P.O. Box 4173 Glendale CA 91202 www.GlendaleHistorical.org

Re: Comment on Sustainable Communities Environmental Assessment (SCEA) for 620 N Brand and 625 N Maryland Ave, Glendale CA 91203

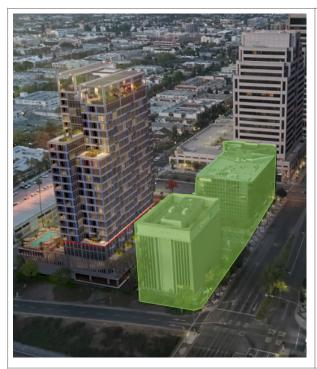
The proposed building at 24 stories would not "step down" as described to align with the existing cornices (see Figure 6). A string course or "a horizontal band... in a building forming a part of the design" is not a step, except on three bays at the slim north side which notably faces the freeway (*Merriam-Webster.com Dictionary*, Merriam-Webster, https://www.merriam-webster.com/dictionary/stringcourse. Accessed 9 Jan. 2022). In the section entitled "Building Design: Massing and Scale," the Downtown Specific Plan directs in a diagram that "High rise massing should be divided to reduce overall bulk and step graciously down towards lower adjacent structures" (page 4-11). We see little stepping and no demonstrated evidence of design courtesy or deference toward the existing, low-rise historic resources.

The project Staff Report asserts "The project effectively utilizes off-set building forms, step-backs, façade modulations and floor plate reductions to lessen the appearance of its mass. The end volumes also step down at their outside corners in order to break down their overall massing, similar to several taller commercial buildings just to the south on the same side of Brand Boulevard (400-550 N. Brand, [Figure 7])." The project provides the absolute minimum step-backs and doesn't compare to those in the block to the immediate south.
